Re: Open House June 25, 2019
Abernethy Way Extension (232 Street to 256 Street)

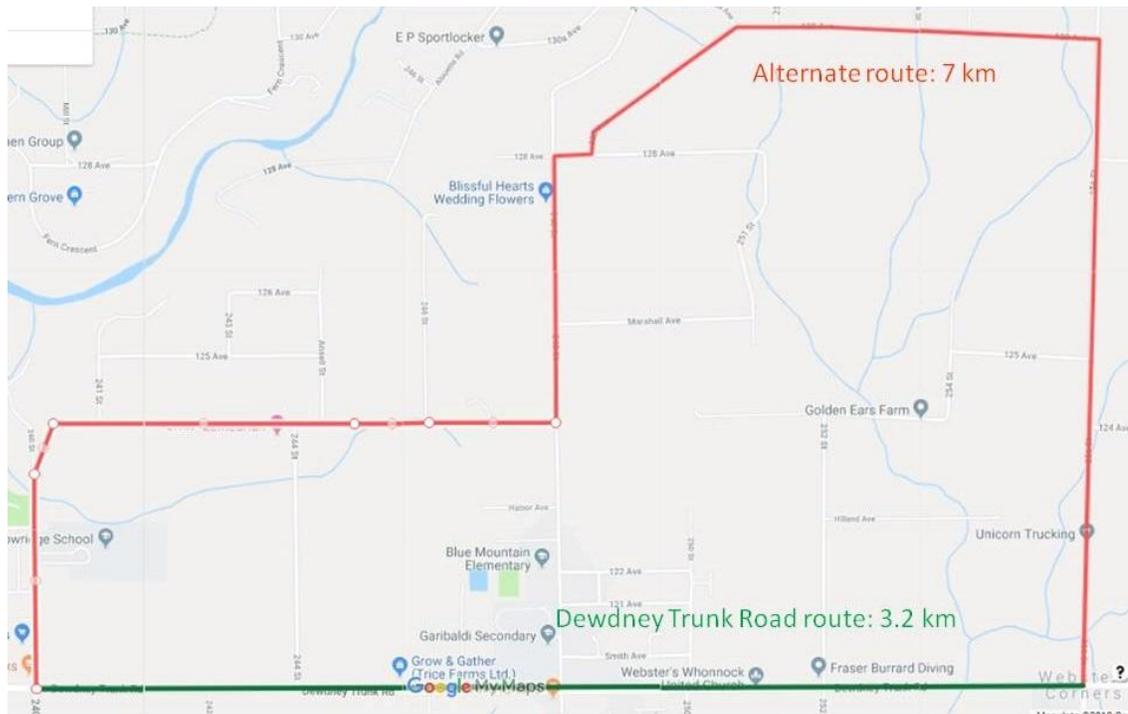
- Presently the only facilities available to children walking and cycling to school, as well as to all people walking and cycling along the Dewdney Trunk Road corridor between 240 Street and 256 Street, are shoulders, with merely a white line as separation between vulnerable road users and high-speed, high volume industrial and other traffic.
- There are no reasonable alternate east-west cycling commuter routes for all ages and abilities. The next best route as an alternative to Dewdney is more than twice the distance:
